Addendum No. 2
March 13, 2025

Project: Brandon Valley Middle School Addition
Brandon, South Dakota
Project #3090

Architect: Architecture Incorporated

9.30-D

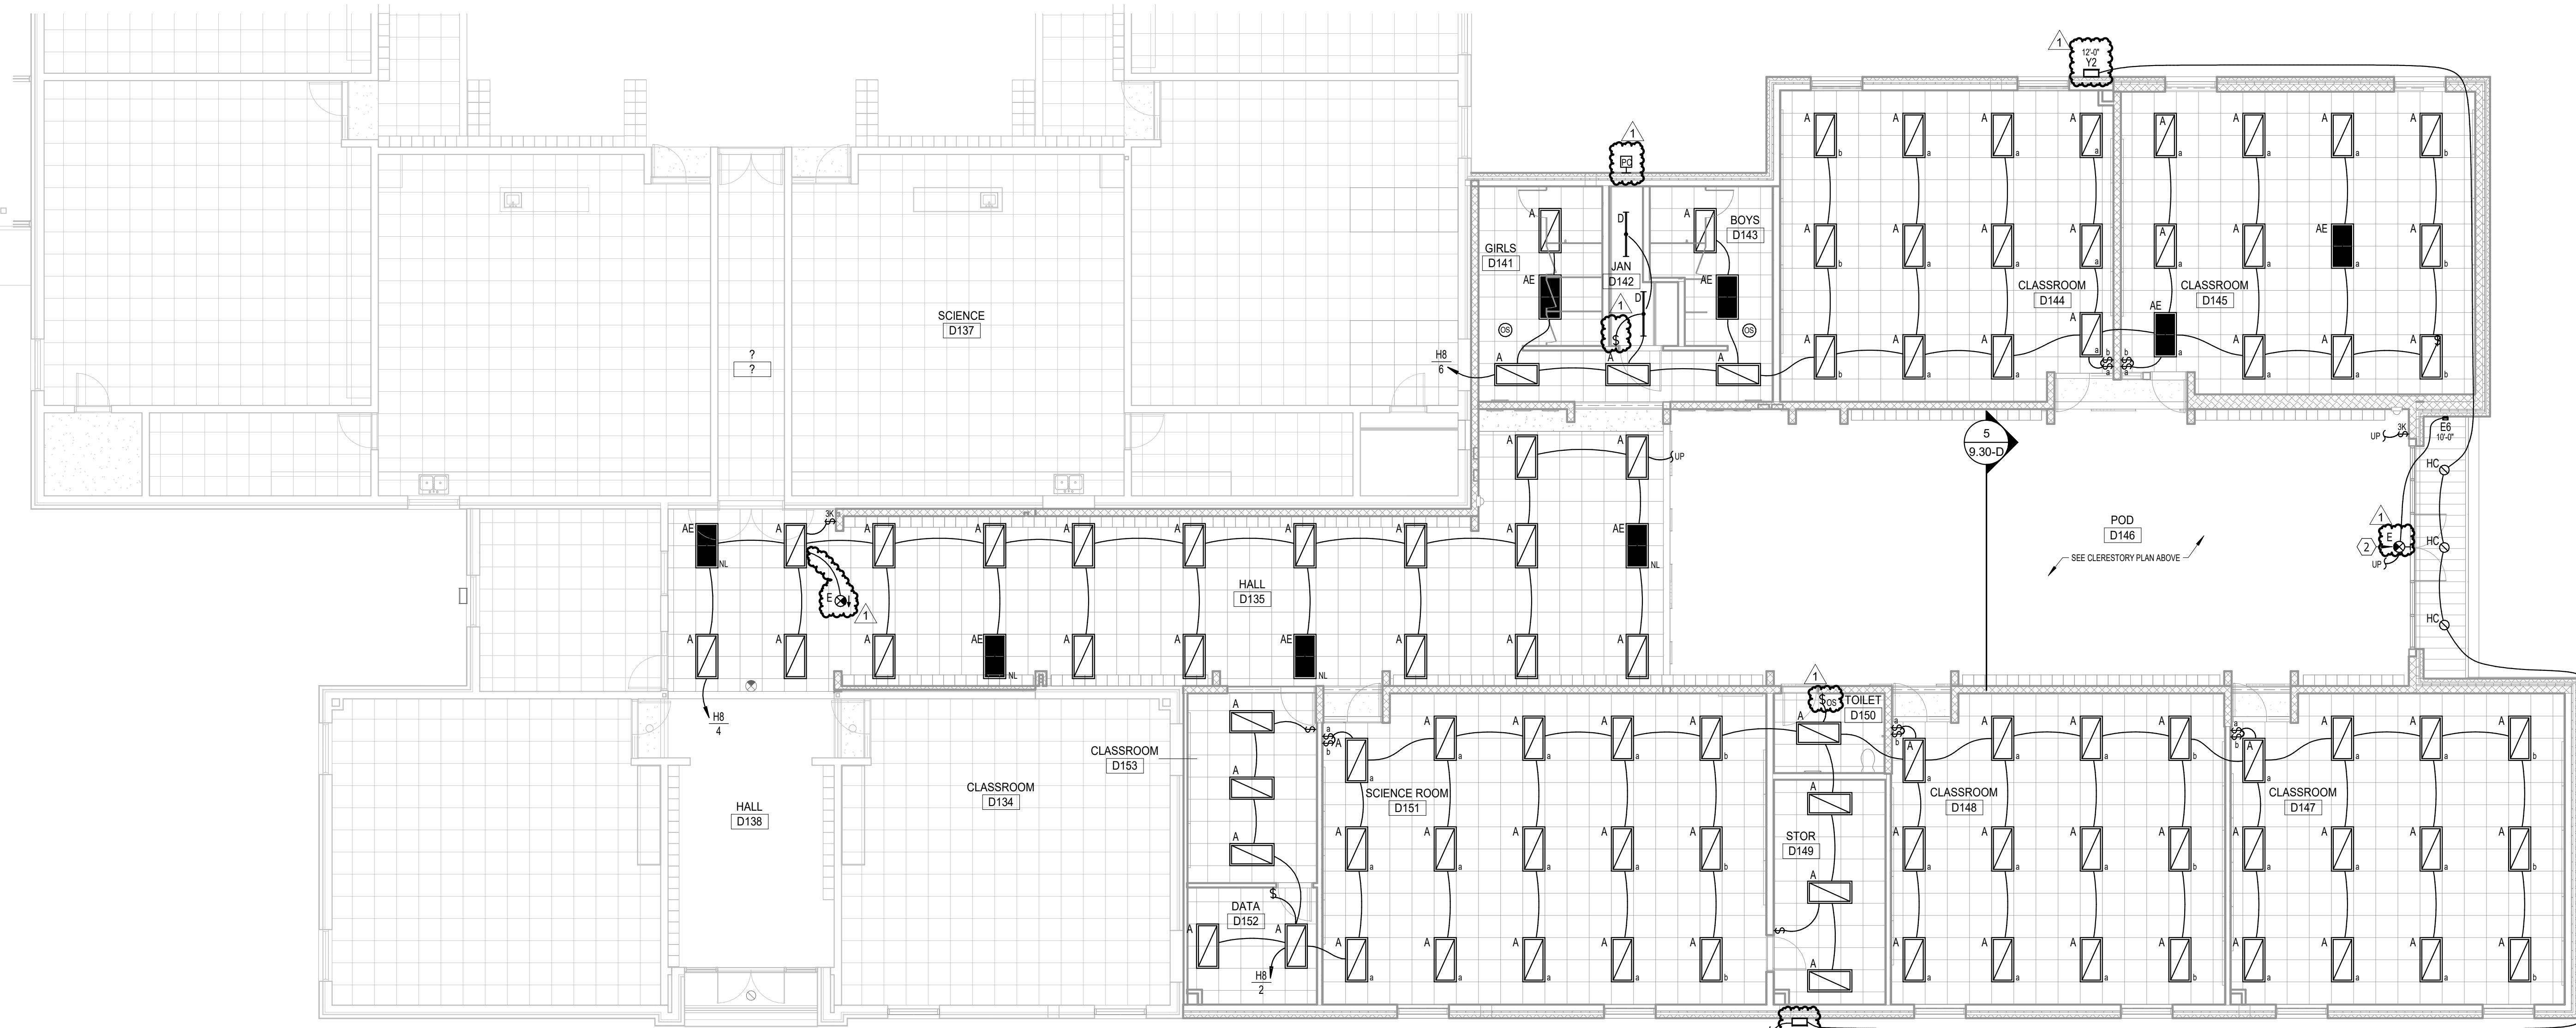
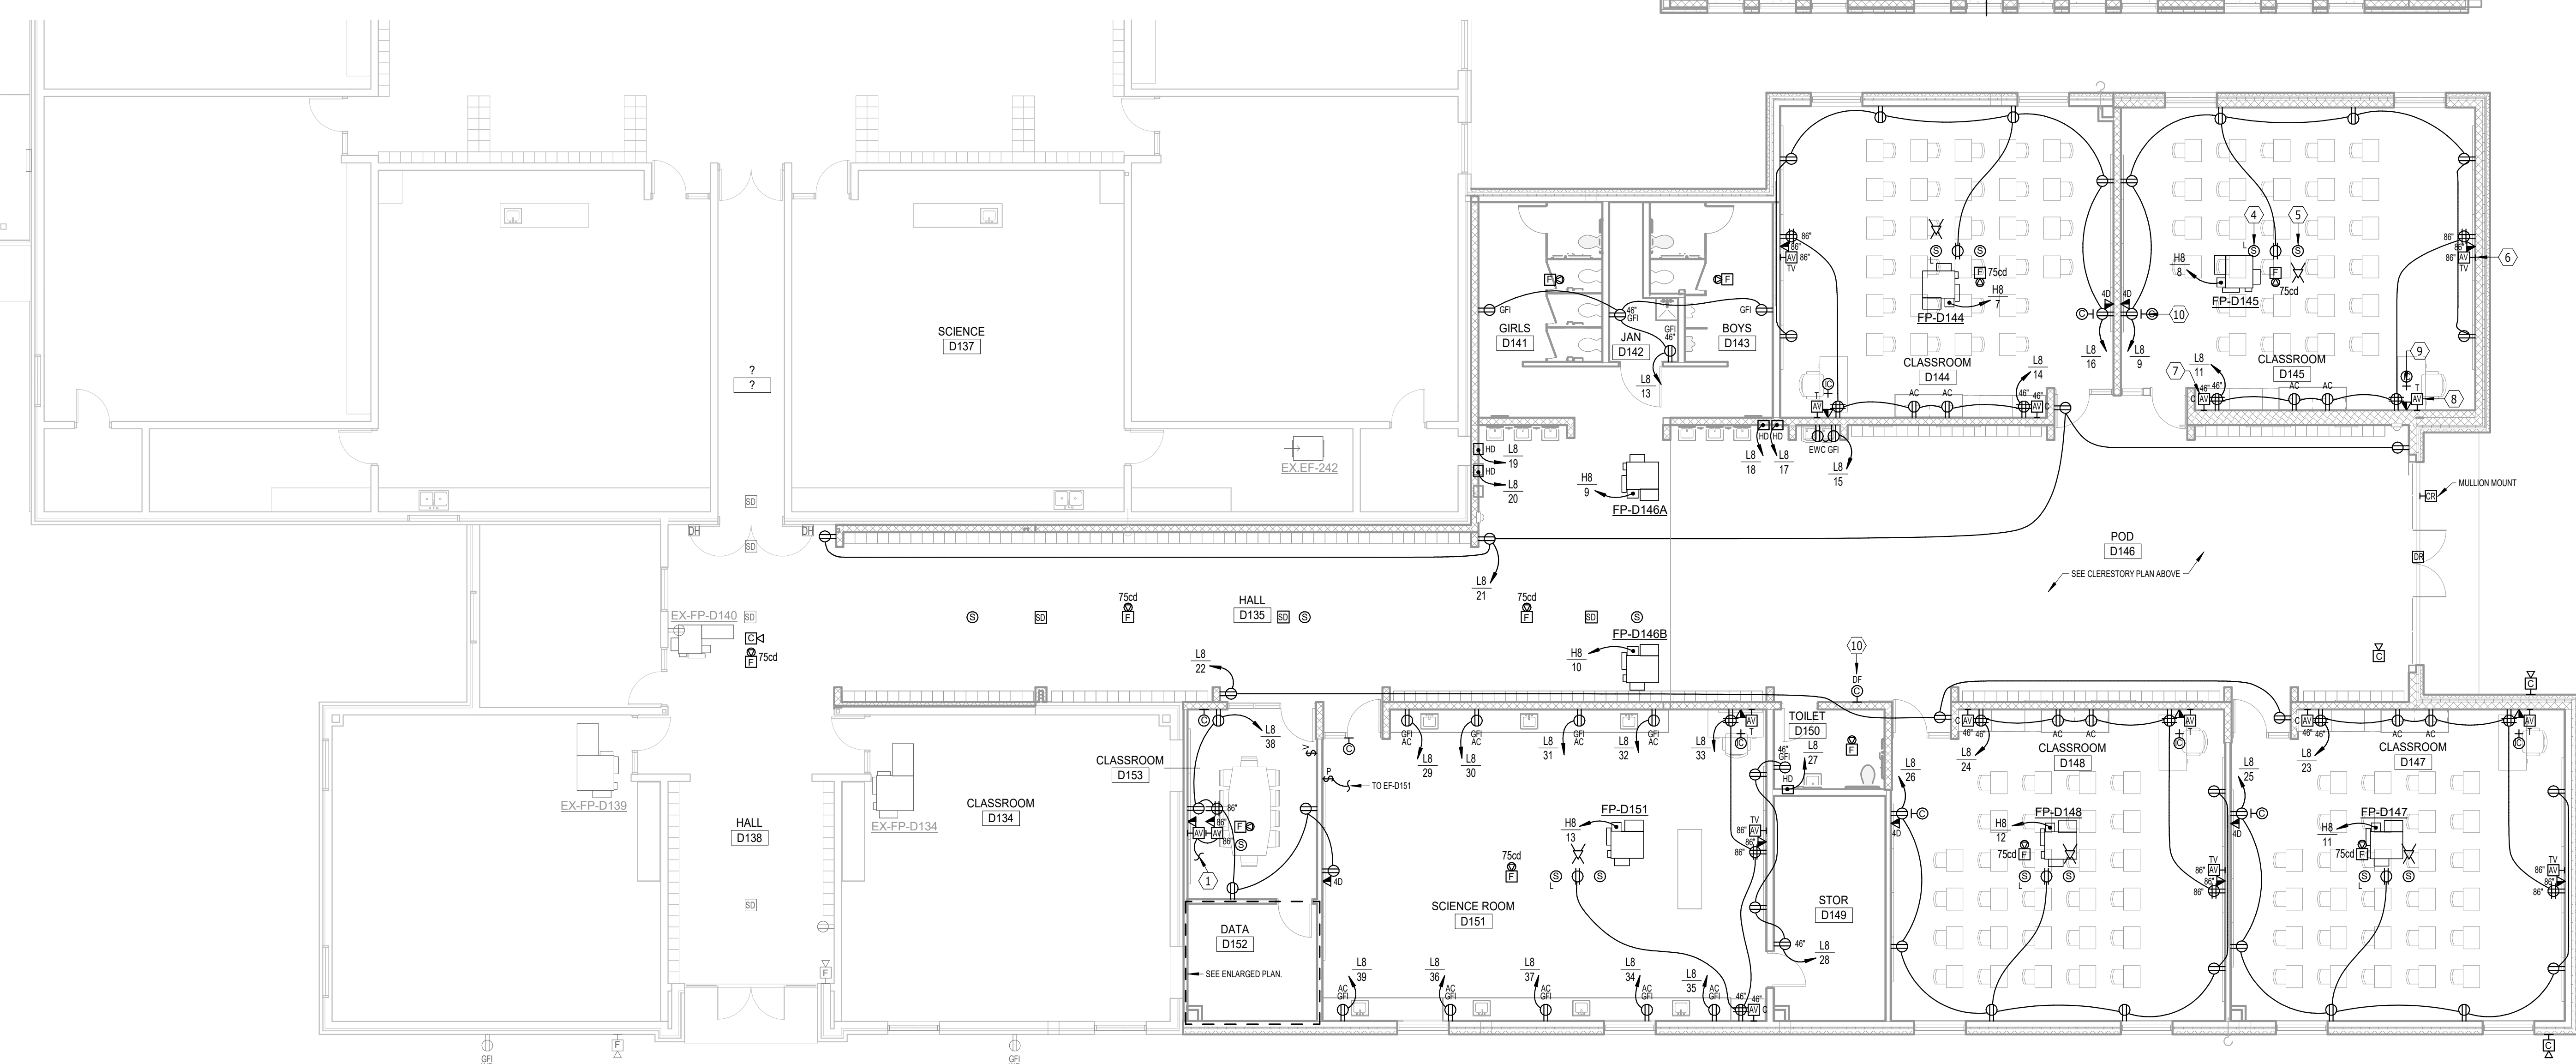
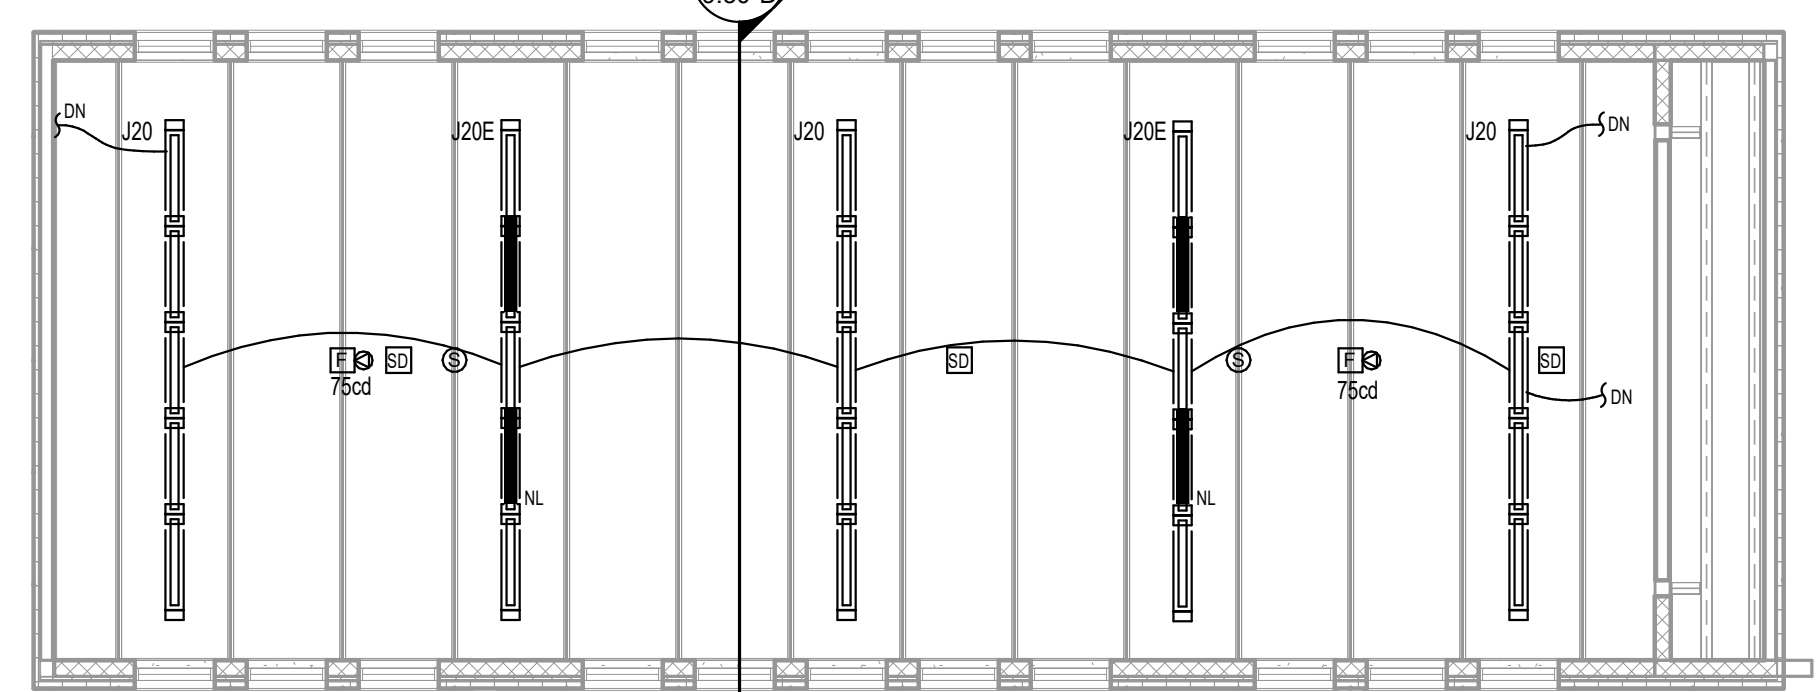
6) SHEET 9.30-D – FLOOR PLAN – AREA D - ELECTRICAL

- a) Reference *revised* Sheet 9.30-D, revision dated 3-13-2025, attached to the end of this addendum for following modifications:
- i) Change Exit light in POD D146 to Type E.
 - ii) Add Type E exit light on west end of Hall B135.
 - iii) Add exterior photocell north of Janitor D142 for new parking lot light control.
 - iv) Add light switch in Janitor D142.
 - v) Change light switch to Occupancy Sensor type in Toilet D150.
 - vi) Change (2) Type Y3 fixtures to Type Y2 on building exterior.

9.40

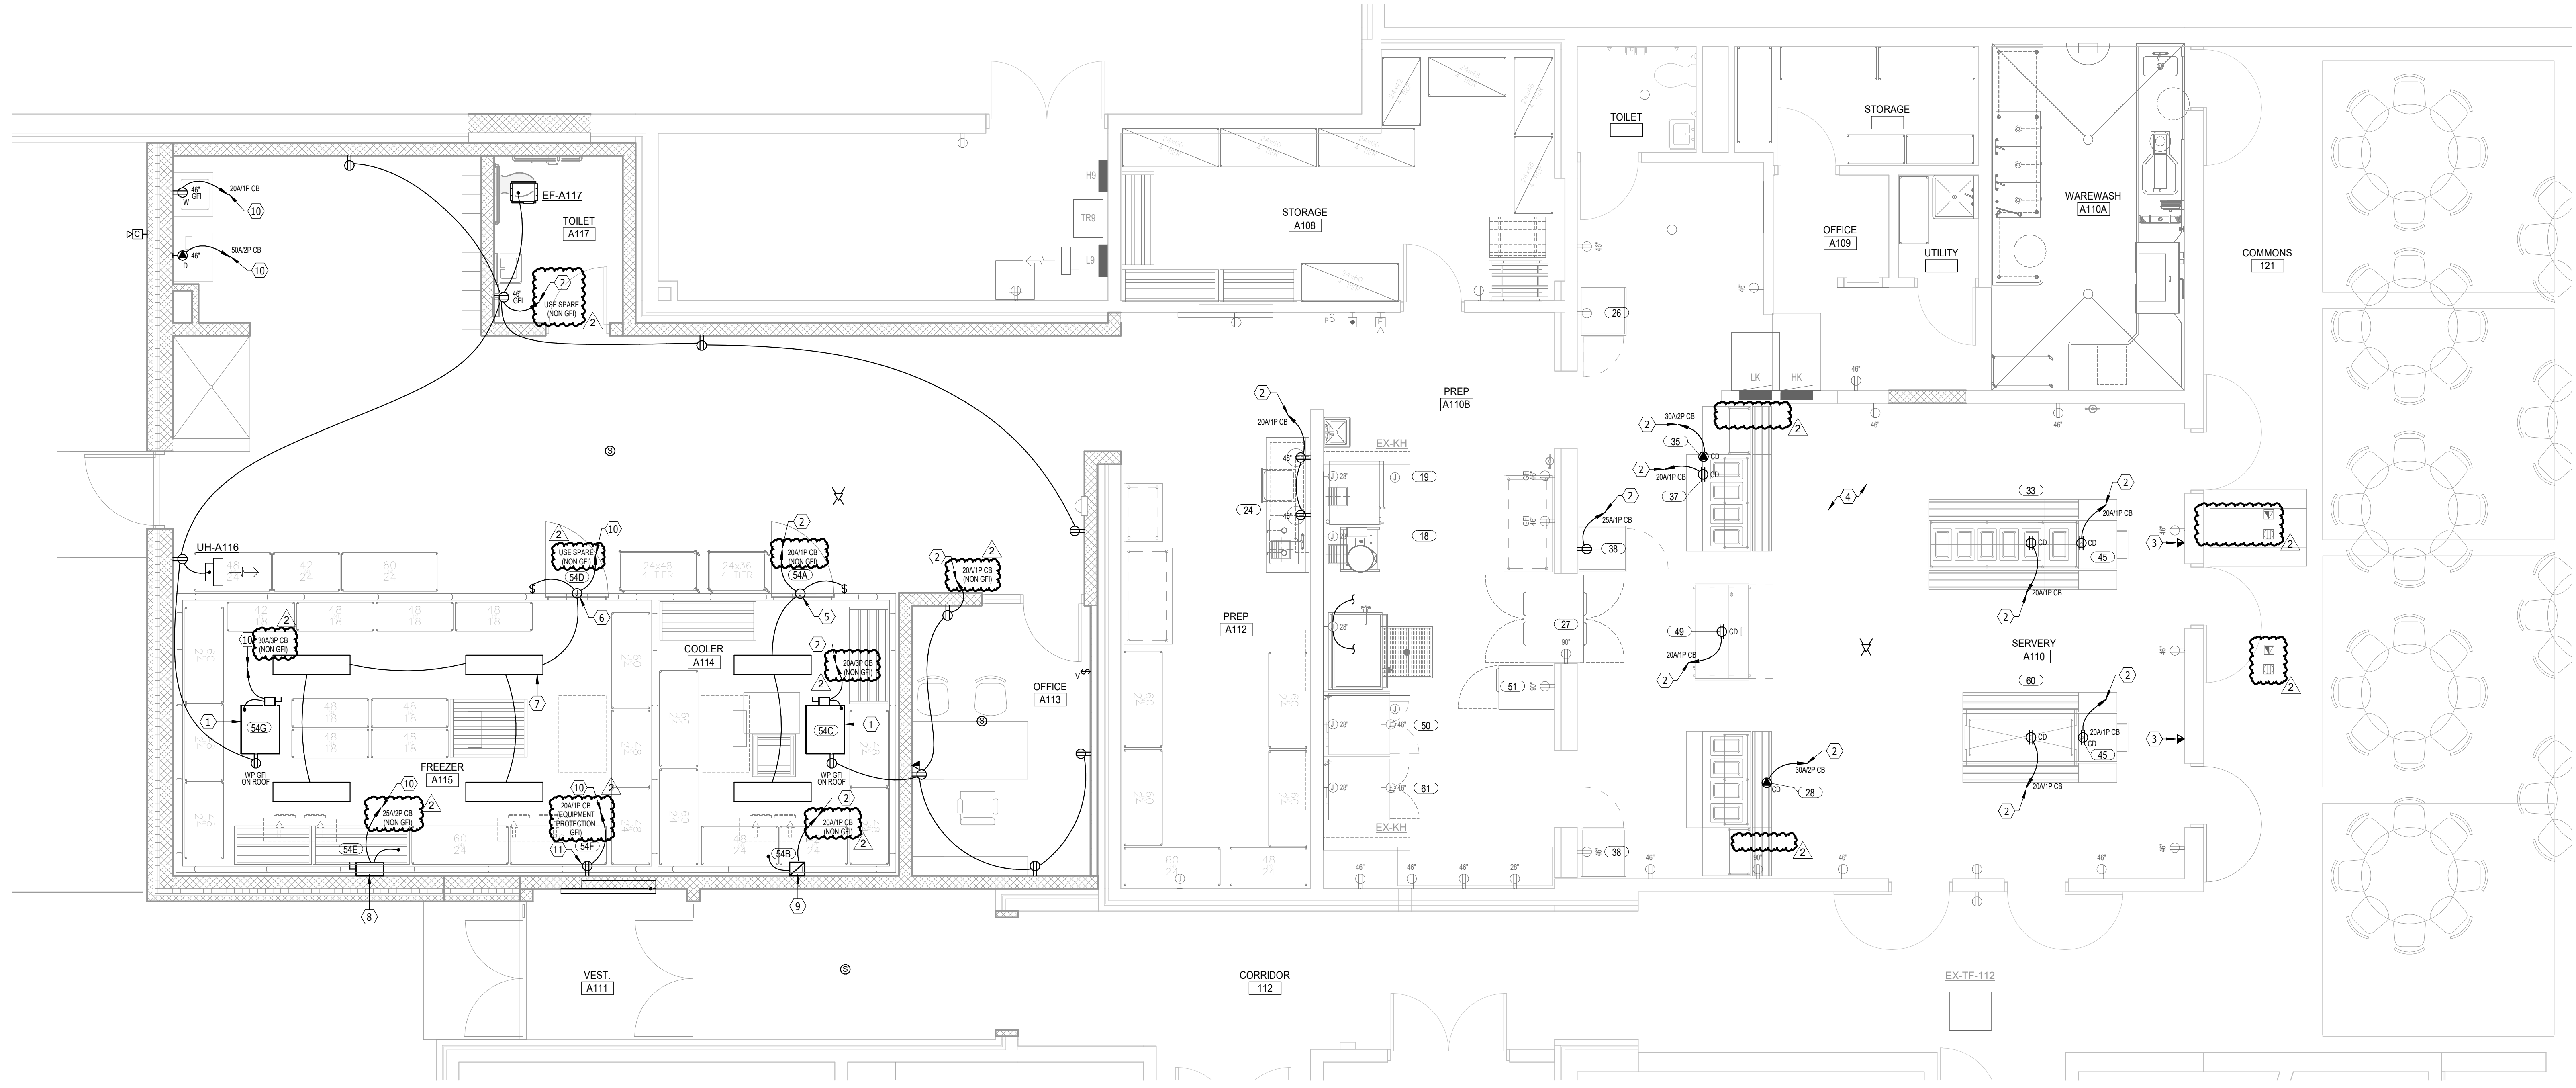
7) SHEET 9.40 – ENLARGED FLOOR PLANS – ELECTRICAL

- a) Reference *revised* Sheet 9.40, *revision* dated 3-13-2025, attached to the end of this addendum for following modifications:
- i) In reference to Servery A110, Remove the Cord Drops, homerun circuits and electrical notes associated with equipment #34 and #36 shown in the original schedule; there are no electrical connections required for these units.

- ii) In reference to Commons 121, Remove the receptacle, homerun circuit and electrical notes associated with equipment #40 shown in the original schedule; there is no electrical connection required for this unit.

- iii) In reference to mechanical schedule, remove electrical connection requirements from Item # 34, 36 and 40.
 - iv) In reference to note #2, update to read as follows: “To Panel LK (General Electric AQ, 10Kaic), connect to circuit made spare from demo of floor boxes. Provide new GFI circuit breaker unless otherwise noted.”.

- v) In reference to note #10, update to read as follows: “To Panel L9 (General Electric AQ, 10Kaic), connect to spare circuit. Provide new GFI circuit breaker unless otherwise noted.”.

- vi) See *revised* electrical drawing Sheet 9.40 for updates to new circuit breakers in the Food Service area.
